Submission on the Visual Impact of the ICC Convention on Goldsbrough Apartments

Submission on the Visual Impact of the ICC Convention on Goldsbrough Apartments

Conybeare Morrison International Pty Ltd (CM+) has been commissioned by The Goldsbrough Apartments to prepare a report assessment on the impact of the proposed Sydney International Convention Centre on the loss of views due to its bulk and height, on the residents of the Goldsbrough Apartments. Redevelopment of Sydney International Convention, Exhibition and Entertainment Precinct is being assessed as a State Significant Development Application under Part 4 of the EP&A Act and SEPP *State and Regional Development 2011*.

Figure 12: Section through the ICC Convention and its impact on views from Goldsbrough
 (source: Architectural drawing – PP_AR_2033(A))

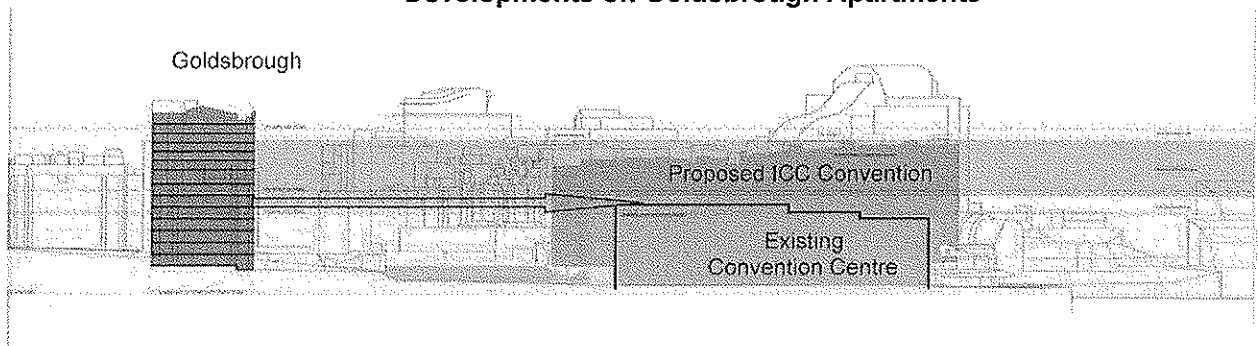
These views, **directly to the east**, will be removed or reduced (from **Levels 5–8**) with the construction of the ICC Convention, with its proposed uppermost roofline approximately 25m (at RL 50.30) above the existing Convention Centre and its western parapet approximately 16m above the existing Centre (at RL 41.30).

Photo 13: View of eastern foreshore of Cockle Bay – of lower building heights (3-4 storeys) along the foreshore, stepping up to higher buildings to enable a more equitable view sharing of the bay and skyline.

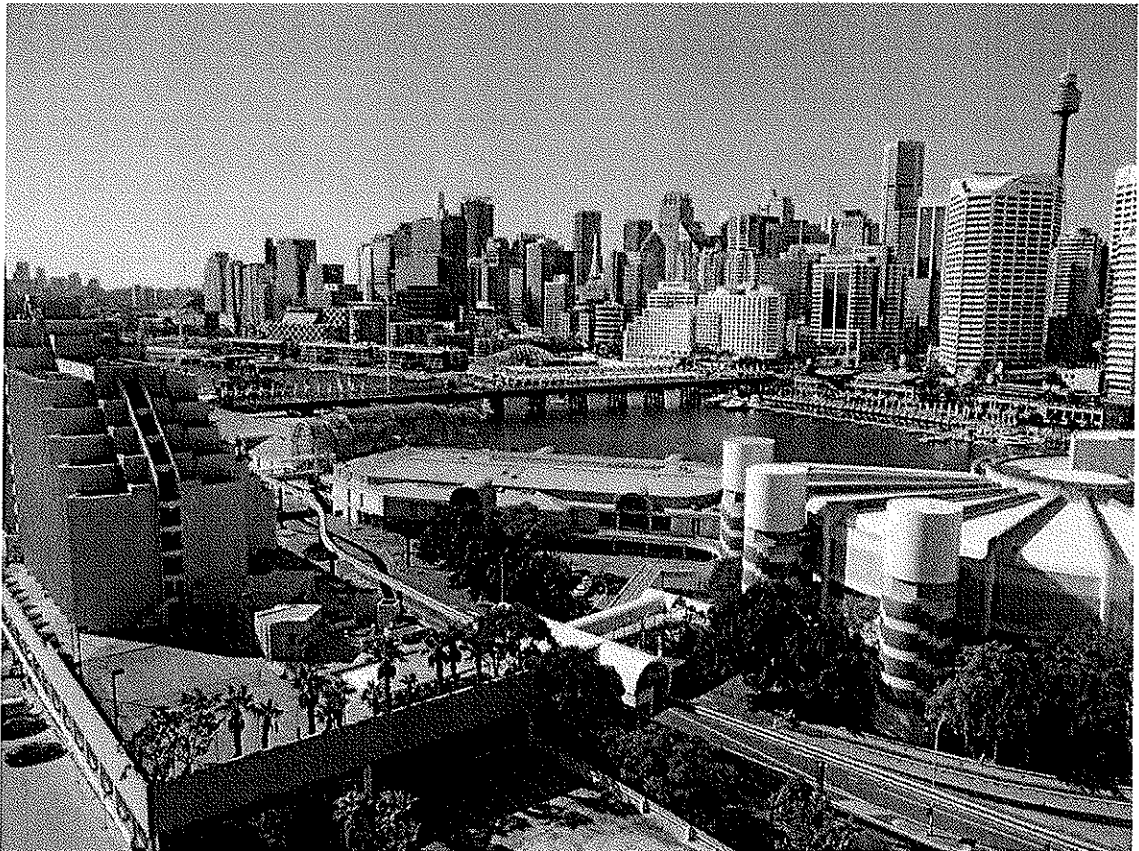
<p>Public Realm Proposed PPP buildings should respond to the built form of the city, to include:</p> <ul style="list-style-type: none"> ▪ Reinforce the consistent building line, height and proportion of their context; ▪ Integrate within existing or new building forms; ▪ Address and respond to significant heritage buildings and spaces. 	<p>The proposed building line at the western foreshore of Cockle Bay is the ICC Convention, sited at a height to RL 50.30 (equivalent to a 12 to 13 storey building with floor levels from 3.6 – 4 m in height). The proposed Convention Centre will be at the same height as the Level 11 of the Goldsbrough Apartments.</p> <p>The consistent building line on the eastern foreshore of Cockle Bay is the 3 storey buildings along the waterfront, stepping up to higher built forms towards the CBD.</p> <p>The height of the proposed ICC Convention is excessive and not consistent with lower building levels along the foreshore. Its height does not</p>

Planning controls	Response
	provide equitable views by buildings behind it to view Cockle Bay and the western Sydney skyline

Figure 23: Impact of proposed ICC Hotel from position P1B – Level 6

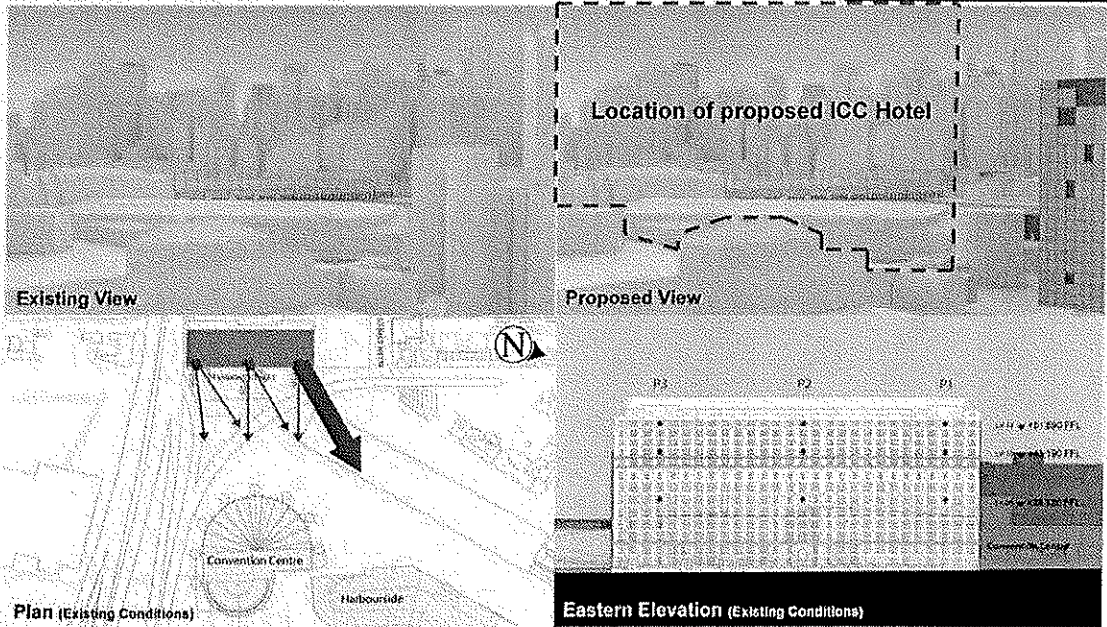
2.	When looking to the north-east (location P1B), the current views will be almost completely unchanged at all levels of the building.	
3.	Looking directly to the east (location P1A), the CBD skyline will still be visible at all levels, however at the lower rise levels, views to some of the smaller CBD buildings will be removed.	<p>With the erection of the proposed Convention Centre, at:</p> <ul style="list-style-type: none"> ▪ Level 5, views east of the western CBD skyline (of mid to upper levels of the higher towers), currently enjoyed, will be mainly eliminated by the proposed Convention Centre; ▪ Level 6, only the uppermost portions of the western skyline will be visible; and ▪ Level 8, the mid to upper portions of the western skyline will be visible.
Views from central section of the eastern side of Goldsbrough (locations P2A & P2B)

Figure 25: Impact of view loss with proposed ICC Hotel from Position P2B – Level 6

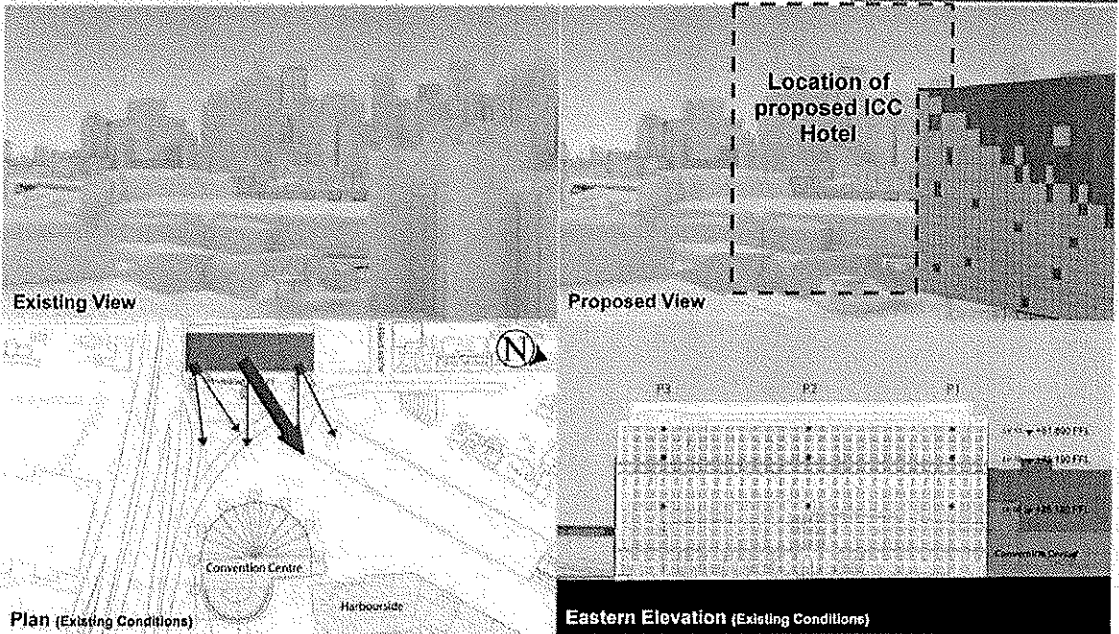
7.	The NE view from apartments (location P2B) will largely be unchanged.	The NE view will still be reduced, with this view corridor impacted dramatically with the erection of the ICC Hotel from the mid-levels of the Goldsbrough (L5-7) – refer to Appendix diagrams.

8.	The new building will be quite prominent in the foreground view from these lower level apartments, however will continue to allow for view sharing of the CBD skyline.	The view sharing of the CBD skyline will not occur from the L5-7 (mid-level) apartments, particularly with the future erection of the ICC Hotel – refer to Appendix diagrams.
Views from central section of the eastern side of Goldsbrough (locations P3A & P3B)

Figure 26: Impact of view loss with proposed ICC Hotel from Position P3B – Level 6

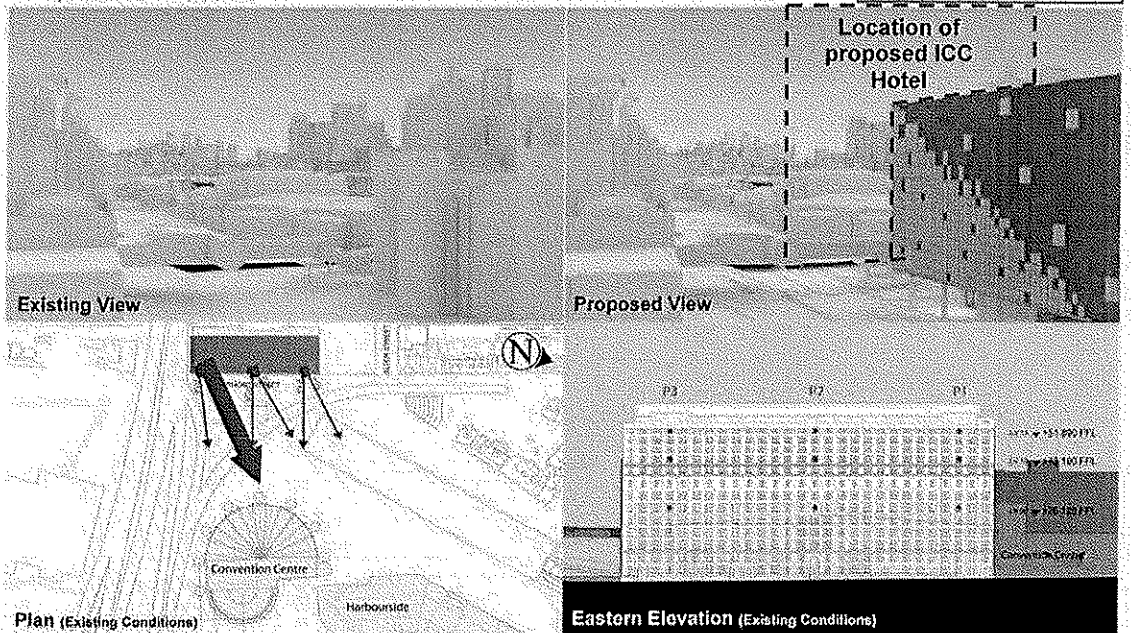
9.	The change in scale of the International Convention Centre complex will partially impact on the SE corner of the field of view when looking towards the CBD skyline.	The proposed Convention Centre and ICC Hotel will impact views from locations P3A & P3B to the NE from Level 8 and below – refer to Appendix diagrams.

11.	Views to the NE from location P3B – apartments at upper and medium levels will lose some views to the southern end of the Darling Harbour waterway as well as views to Pyrmont Bridge.	Views to the NE to Darling Harbour waterway, North Sydney and Barangaroo, from mid to upper levels of the Goldsbrough, will be lost with the future erection of the ICC Hotel, which whilst not part of this development application, must be considered with this application, as the height of the proposed ICC Convention, if approved, will set a precedence of high buildings (rather than the current lower buildings) along the foreshore.
